RE: Vesting Tentative Parcel Map 18-04 (Karansinski), 1249 W. Lindo Avenue, APN 043-630-005

Subdivision Report

RE: **Vesting Tentative Parcel Map PM 18-04 Karasinski - Lamb**

This office has reviewed the vesting Tentative Parcel Map PM 18-04 Karasinski - Lamb and herewith submits the following findings and recommendations for same.

WEST LINDO AVENUE
& FERN AVENUE
WITH ON-STREET PARKING

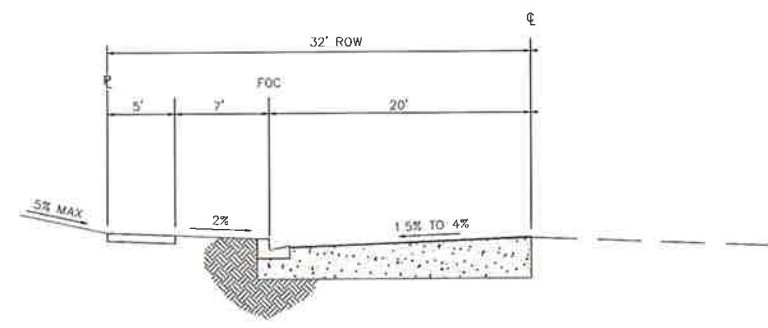
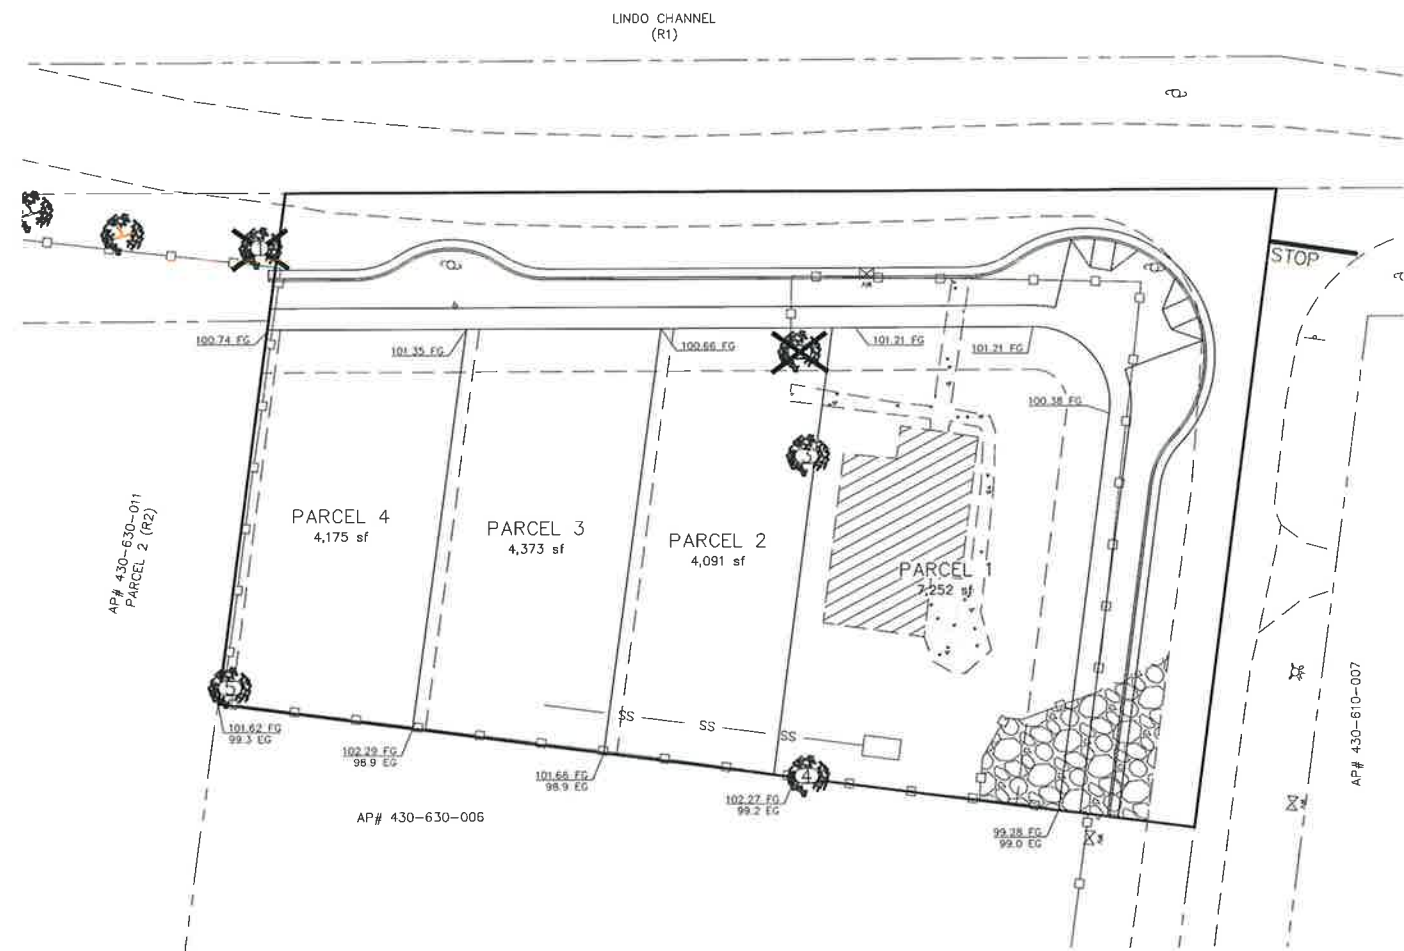
1. **Request:** Non-standard street sections.

- a) The Subdivider shall construct City standard streets and appurtenant facilities at the following locations in conformance with the typical sections attached hereto as Exhibit A:
 - 1) Adjacent to subdivision - West Lindo Avenue and Fern Avenue frontages, including corner bulbing at West Lindo Avenue and Fern Avenue.
- b) All corner lots shall be subject to intersection sight distance criteria as established by the Public Works Director. Appropriate easements shall be dedicated as needed on the Final Map.

Recommendation: Acceptable.
